MISSISSIPPI DEPARTMENT OF TRANSPORTATION

PROJECT: ACNH-9204-00(007) / 100486301 – Madison County

SUBJECT: Questions and Answers

SUBJECT: Safety Edge

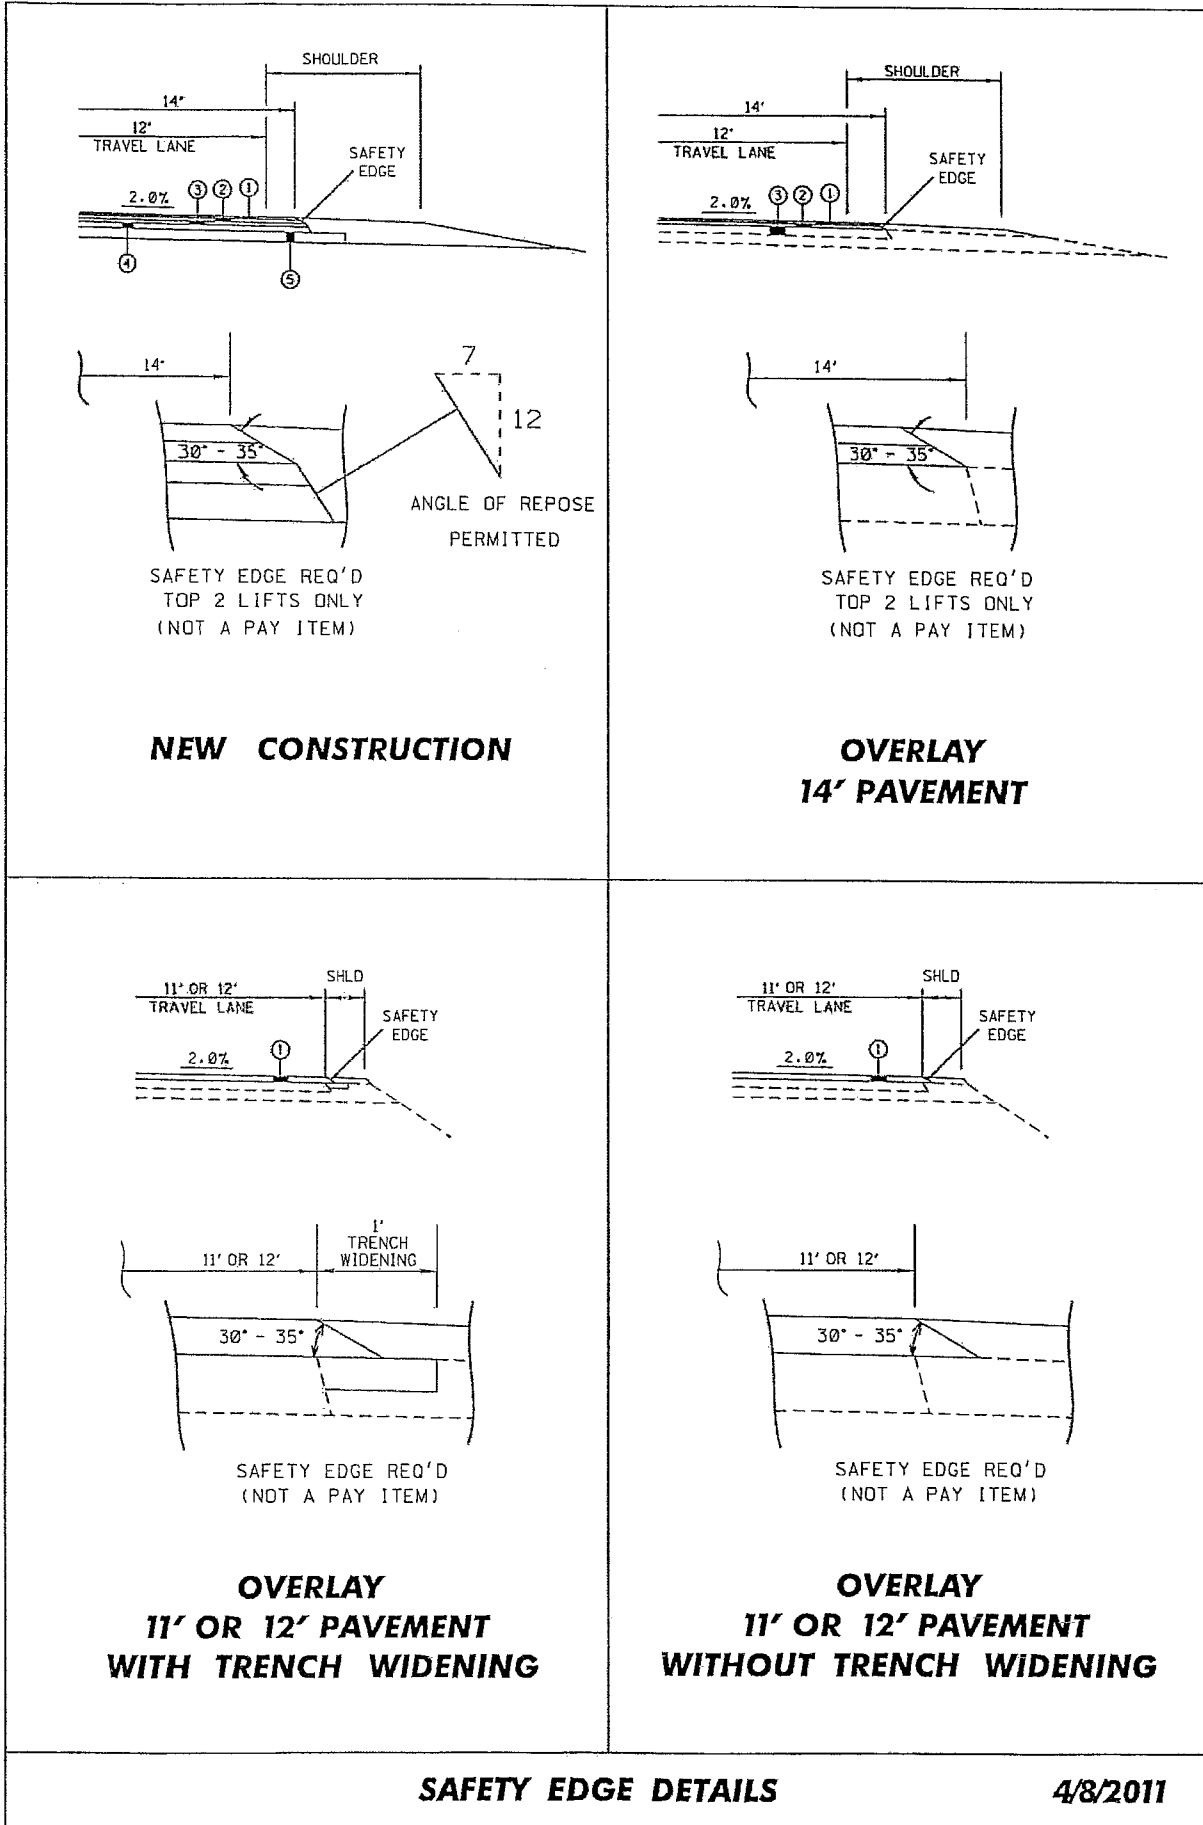
Bidders are hereby advised that the Shoulder Wedge (Safety Edge) specified in the Supplement to Special Provision 907-401-2 shall only apply to the top two (2) lifts of asphalt. Attached is a drawing showing the safety edge.
